Access Compliance Report

Public Rights-of-Way

(Curb Ramps)

Intersection ID: 54372	Main Street: ARNOTT_LN	Cross Street: CALLONWOOD_DR	Location: SW
ADA ID: C3CC8F7965E9	Ramp Type: Perp	Initial Pass/Fail: Fail	Overall Compliance: No
			Severity Score: 21.25

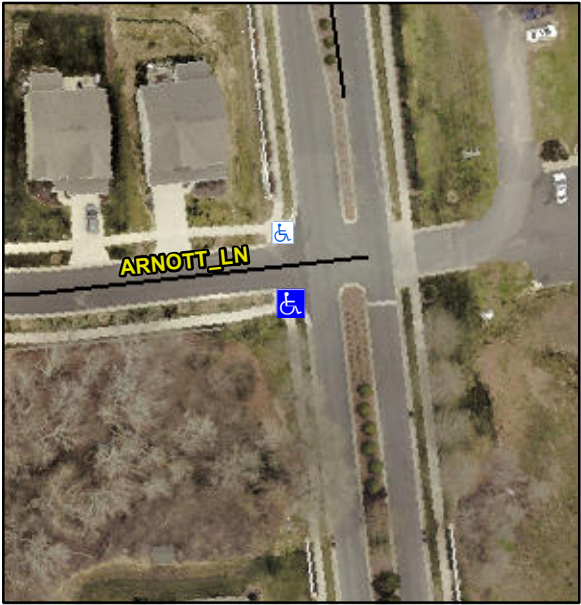
Codes/Mitigation Info/Possible Solution			Field Measurements/Component Compliance		
	Possible Solutions:		Compliance	Description	Data
	Remove & Replace Entire Ramp.		N/A	Ramp Length (in)	63.5
			No	Ramp Width (in)	47.0
			N/A	Flare Type LT	N/A
			N/A	Flare Slope LT (%)	N/A
			N/A	Flare Traversable LT?	N/A
			N/A	Landing Length (in)	N/A
			N/A	Landing Width (in)	N/A
			N/A	Landing Slope (%)	N/A
			N/A	Landing X Slope (%)	N/A
Surveyor Notes: N/A PROW/ADA: Not Found, R304.5.1, R304.5.3			N/A	Flare Type RT	N/A
			N/A	Flare Slope RT (%)	N/A
			N/A	Flare Traversable RT?	N/A
			N/A	DWS Provided?	N/A
			N/A	DWS Contrast?	N/A
			N/A	DWS Length (in)	N/A
			N/A	DWS Full Width?	N/A
			N/A	DWS Offset (in)	N/A
			N/A	Gutter Ponding?	N/A
			N/A	Gutter Lip Ht (in)	N/A
Total Cost: \$ 1850.00			No	Painted X Walk2?	N/A
				X Walk 1 Direction	To N
			N/A	X Walk 2 Direction	N/A
			N/A	X Walk 1 Width (in)	N/A
			N/A	X Walk 2 Width (in)	N/A

5.2	X Walk 1 Slope (%)	N/A
			4.7	X Walk 2 Slope (%)	N/A
			N/A	X Walk 1 X Slope (%)	N/A
			N/A	X Walk 2 X Slope (%)	N/A
			N/A	Ramp inside XWalk1?	N/A
			N/A	Ramp inside XWalk2?	N/A
			N/A	Road Slope (%)	N/A
			N/A	Clear Space?	N/A
			N/A	Clear Space to XWalk (in)	N/A
			N/A	Road X Slope (%)	N/A
			N/A	Storm Grate/Utility Hazard?	N/A
			N/A	Storm Grate/Utility Type	N/A
			N/A	Obstruction Type	N/A
			N/A	Surface Condition? (G/P)	Good
